ADDENDUM NO. 2

April 22, 2024

SOUTHWEST SIDE WATER MAIN REPLACEMENT PHASE 4
O. F. 1432.5

FLOWABLE FILL TRENCH PLUG

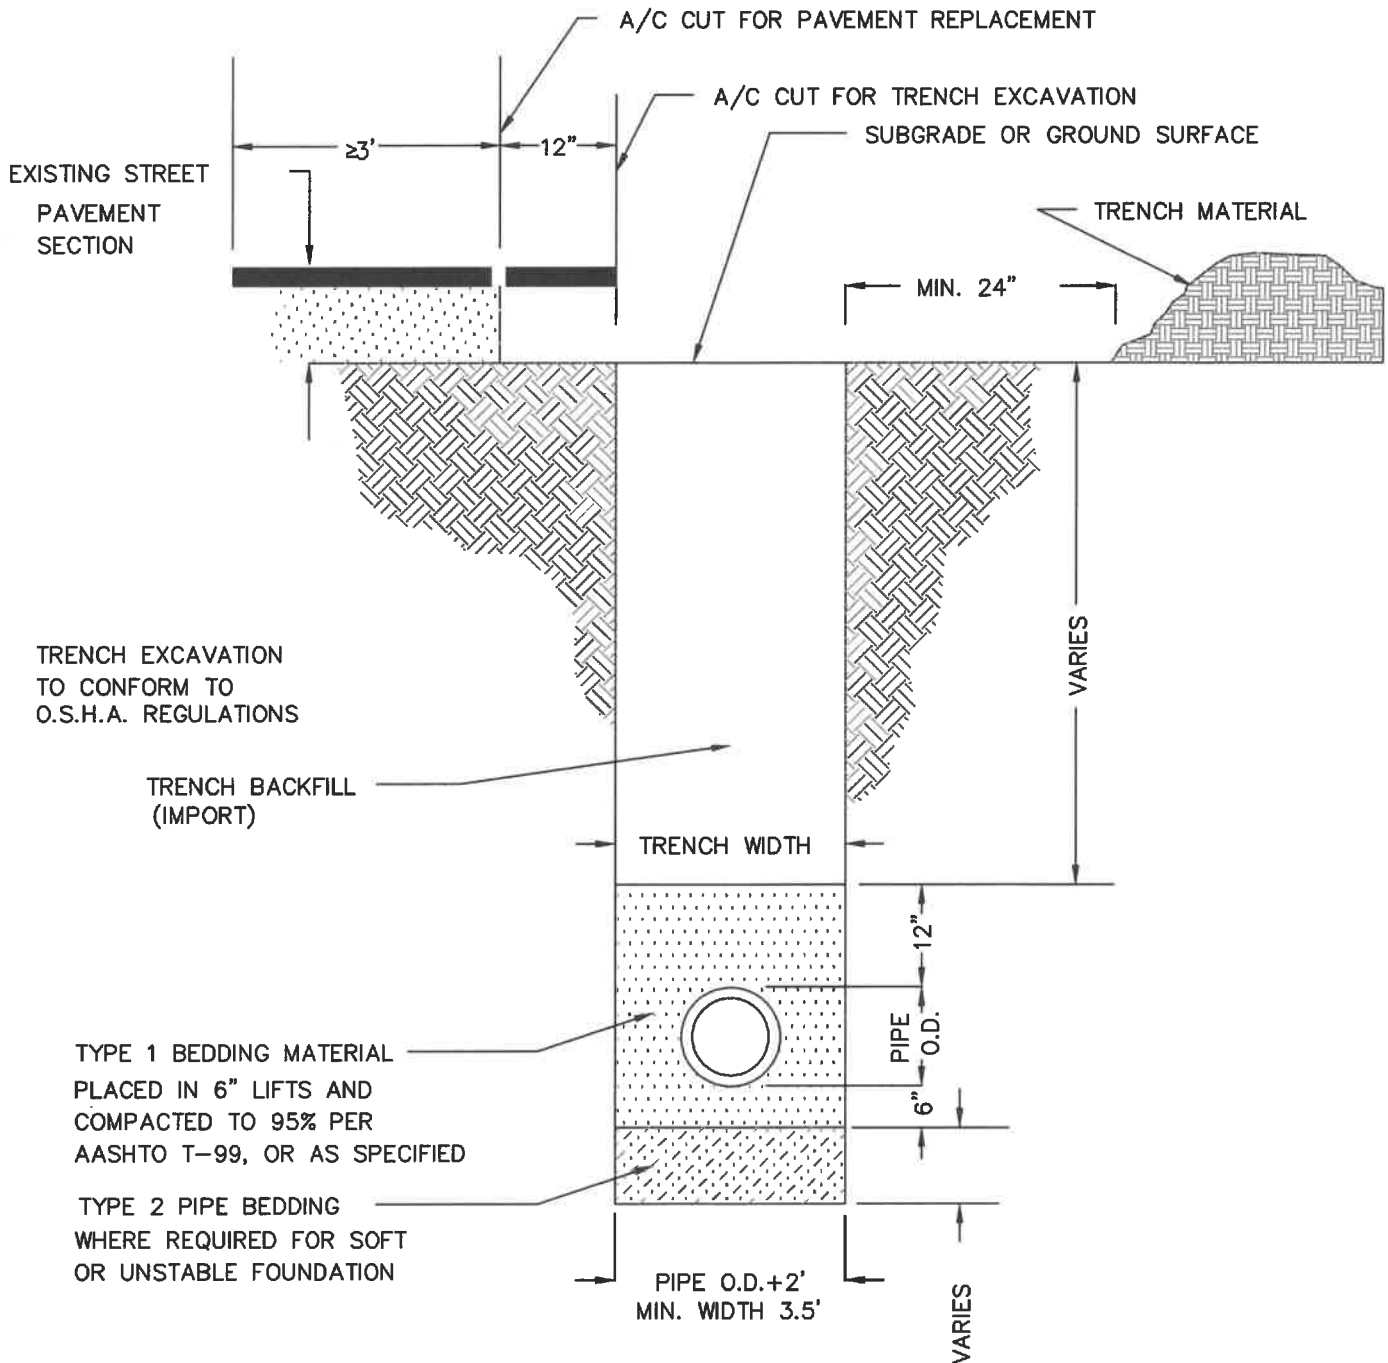
Add attached 1432.5 5-34 Flowable Fill Trench Plug Drawing

Note: Trench plugs every 100 ft when using open graded aggregate per Technical Specifications Section 02221, 2.1, A

TYPICAL TYPE 2 TRENCH DETAIL

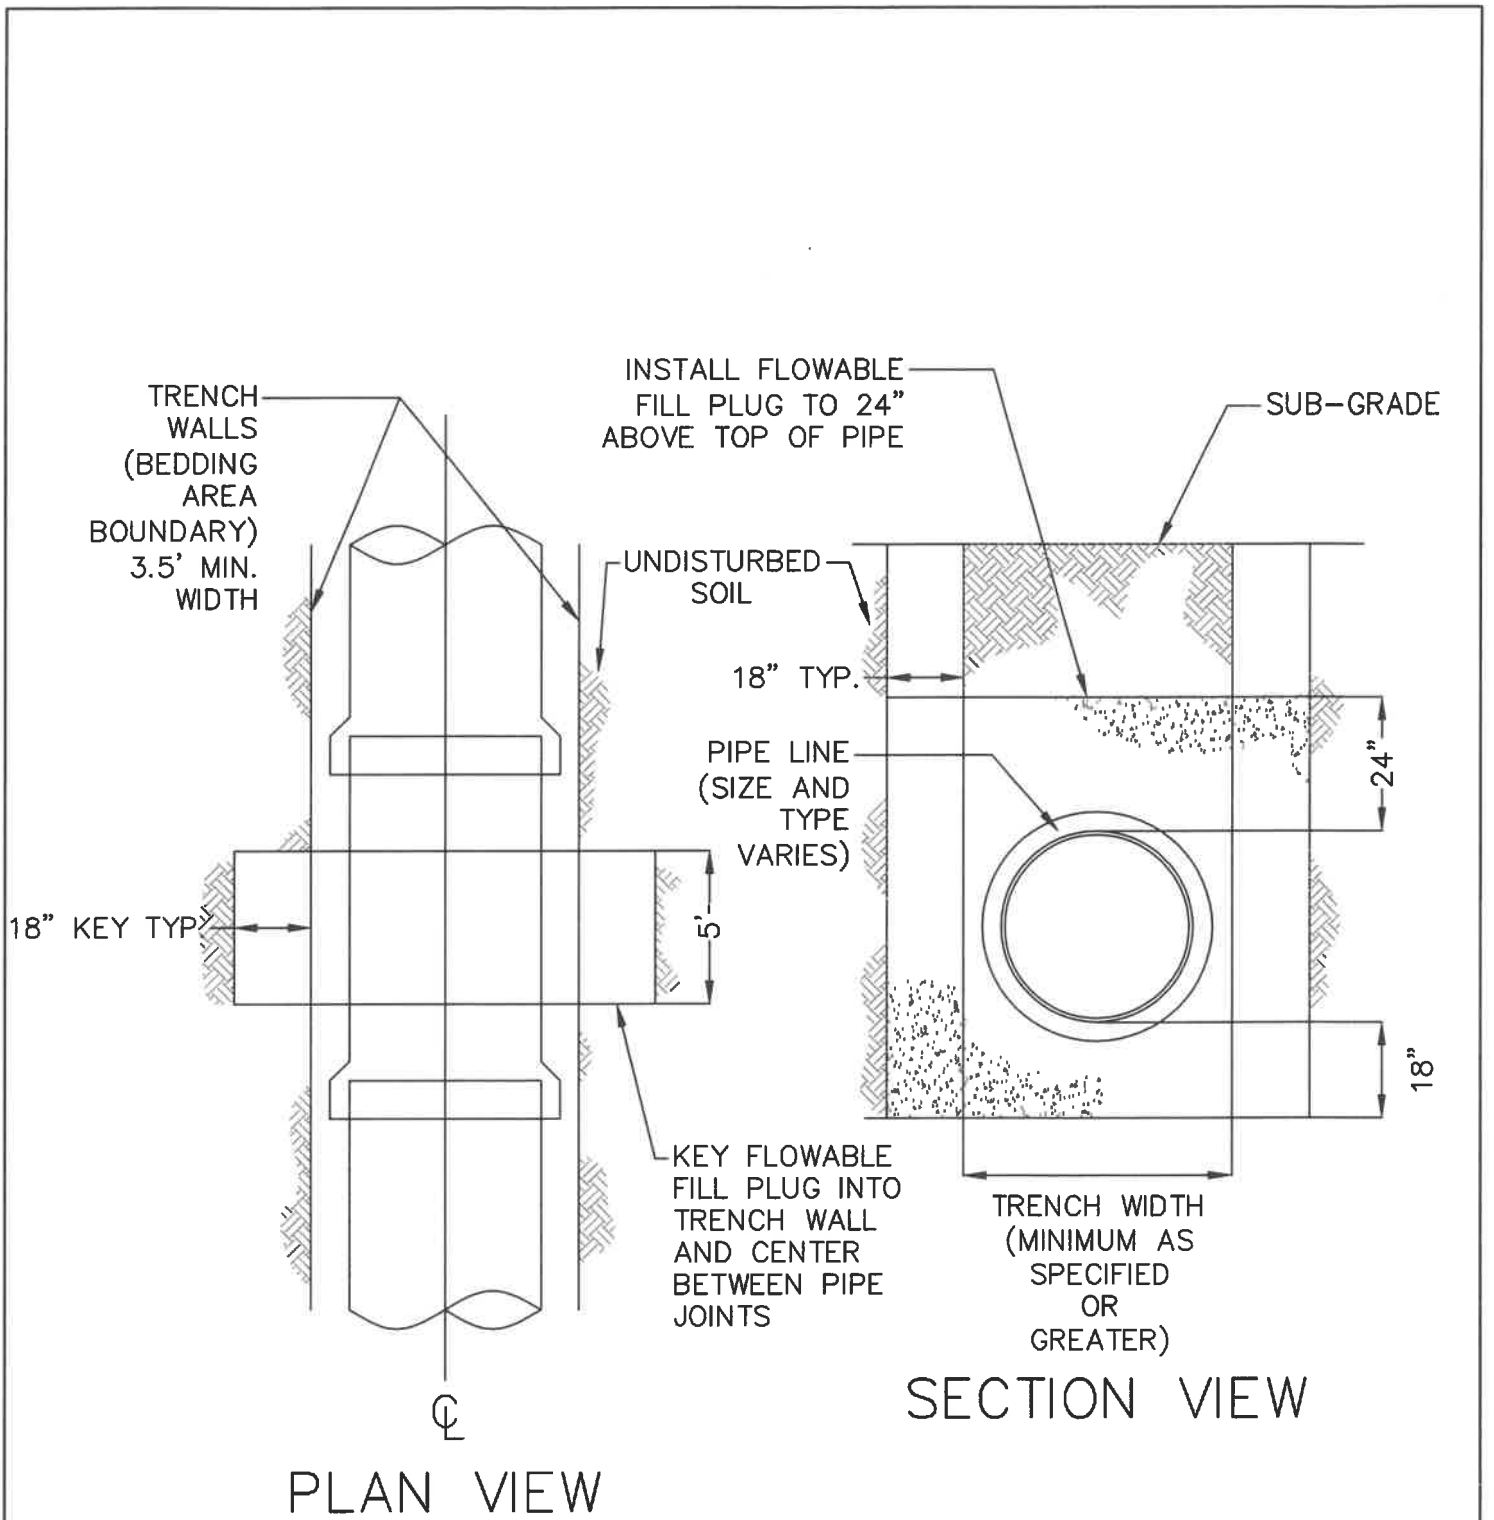
Replace 1432.5 5-31 Drawing with attached updated 1435.5 5-31 Drawing (Revised April 2024)

Note: Pipe Bedding increased to 6” below pipe and 12” above pipe
